E8357A-03

S E R V I C E N O T E

E8357A PNA Microwave Network Analyzers

Figure 1: A3 Front Panel Interface Board Assy without the Bracket

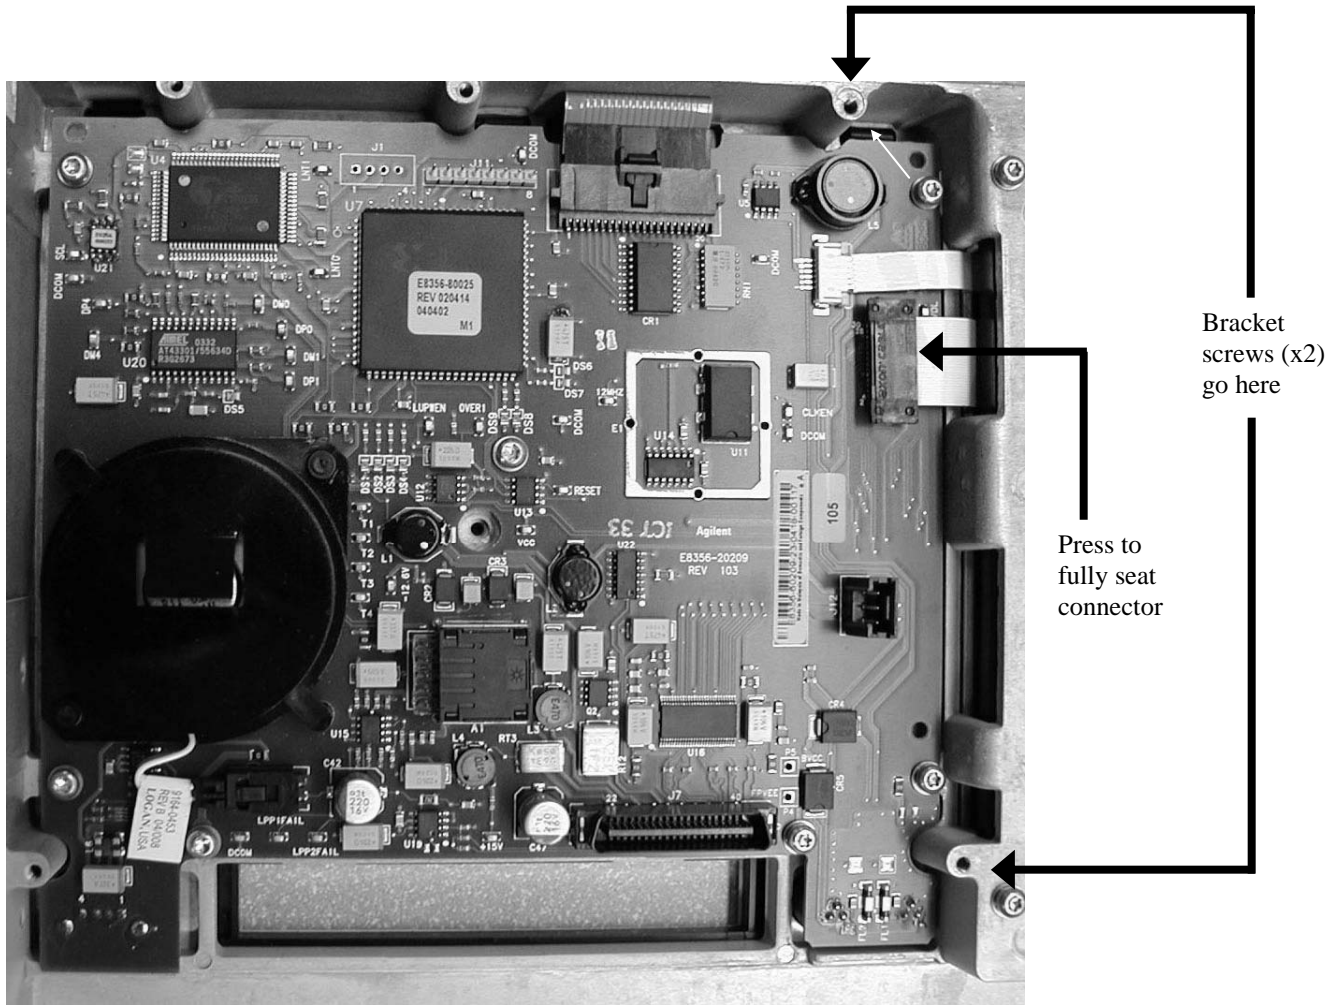
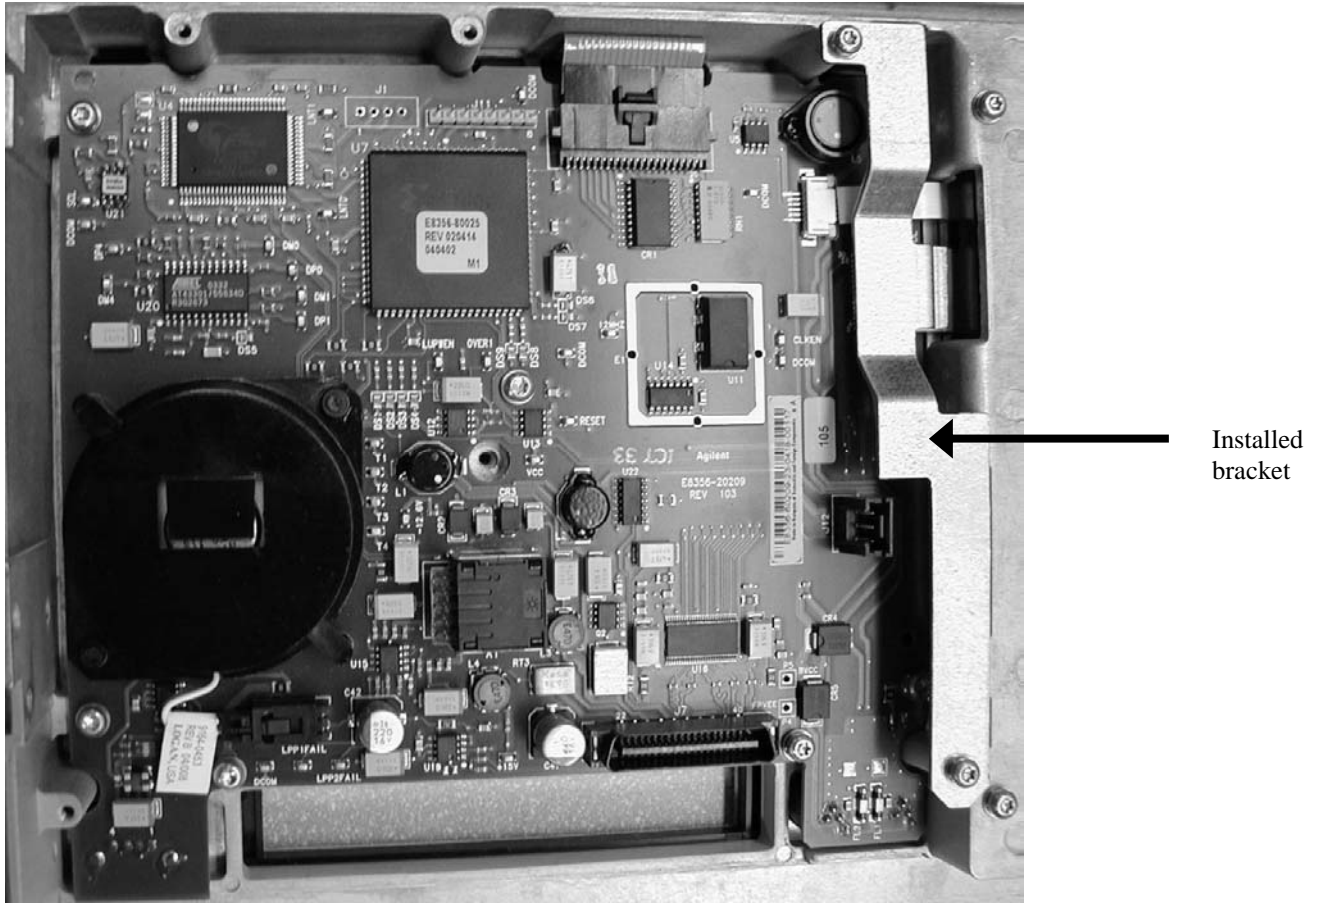
A connector of the ribbon cable (Agilent part number 8120-8409) that joins the front panel display to the front panel interface board can loosen, causing a display failure, unless a new bracket is installed. Because the failure rate has been very low, it is recommended that the bracket be installed only when there is an additional reason to remove the PNA front panel.

1. Refer to Figure 1 in this document:
 - Press down firmly on the ribbon cable's black connector.
 - Locate the two tapped holes for the bracket screws.
2. As shown in Figure 2 in this document, position the bracket so that its holes line-up with the two holes you located in the previous step.
3. Hand-start the two screws, and then torque both to 9 in-lbs.
4. Reinstall the PNA Front Panel by following the Service Guide instructions in the "Replacement Procedure." This is located on the same page as the "Removal Procedure" used previously in step 7.
